# **Wollongong Local Planning Panel Assessment Report | 13 August 2020**

<b>WLPP No.</b>	Item 2
<b>DA No.</b>	DA-2020/291
<b>Proposal</b>	Retail premises – Service Station
<b>Property</b>	70-74 Kurrajong Street, Windang and 217-221 Windang Road, Windang
<b>Applicant</b>	Isaac Property Development
<b>Responsible Team</b>	Development Assessment and Certification - City Centre Team (NM)

The proposal seeks consent for the construction and use of a service station including construction of an awning, retail outlet, parking, landscaping and signage.

**Figure 2:** West elevation wall sign

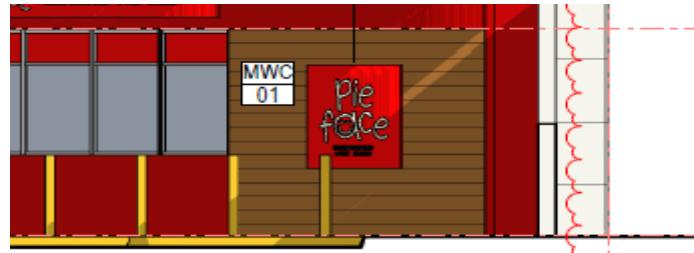
2 flush wall signs are proposed, including 1 on the north elevation and 1 on the east. Neither sign occupies more than 20% of the elevation.

**Figure 3:** pylon sign

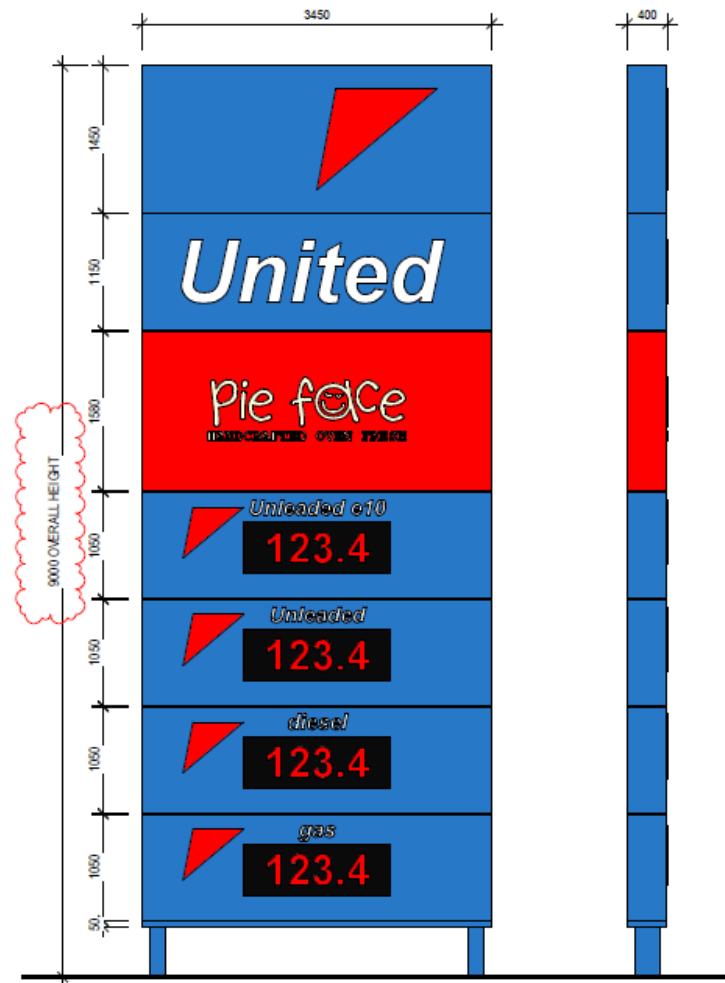
1 proposed pylon sign is proposed. The height of the proposed sign is 9m, which exceeds the requirements of the DCP, but is consistent with the LEP maximum height of 9m.
